UNITED STATES
DEPARTMENT OF THE INTERIOR
BUREAU OF LAND MANAGEMENTFORM APPROVED
OMB NO. 1004-0137
Expires: January 31, 2018**SUNDRY NOTICES AND REPORTS ON WELLS**
*Do not use this form for proposals to drill or to re-enter an abandoned well. Use form 3160-3 (APD) for such proposals.*5. Lease Serial No.
NMNM114819

8. Well Name and No.
BILBREY 27A FED 19. API Well No.
30-025-31095-00-S110. Field and Pool or Exploratory Area
BILBREY11. County or Parish, State
LEA COUNTY, NM**SUBMIT IN TRIPLICATE - Other instructions on page 2**

PROPOSED PLUG & ABANDONMENT

CURRENT WELLBORE

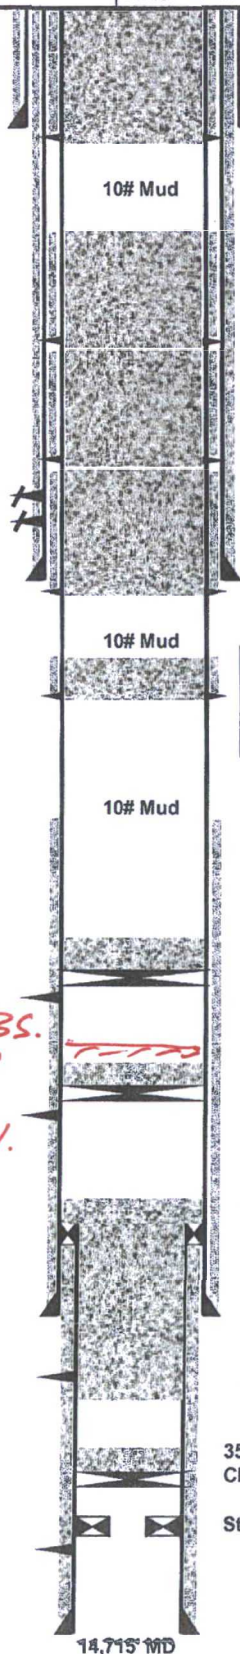
*Add 180' plug cover top BS.
 May extend into Del. Ports or*

*go ahead and cover all del.
 per FS.*

20' cement. 9,380' PBD.
 CIBP @ 9,400' (8/20/95) *Add 25 sx min. Plug*
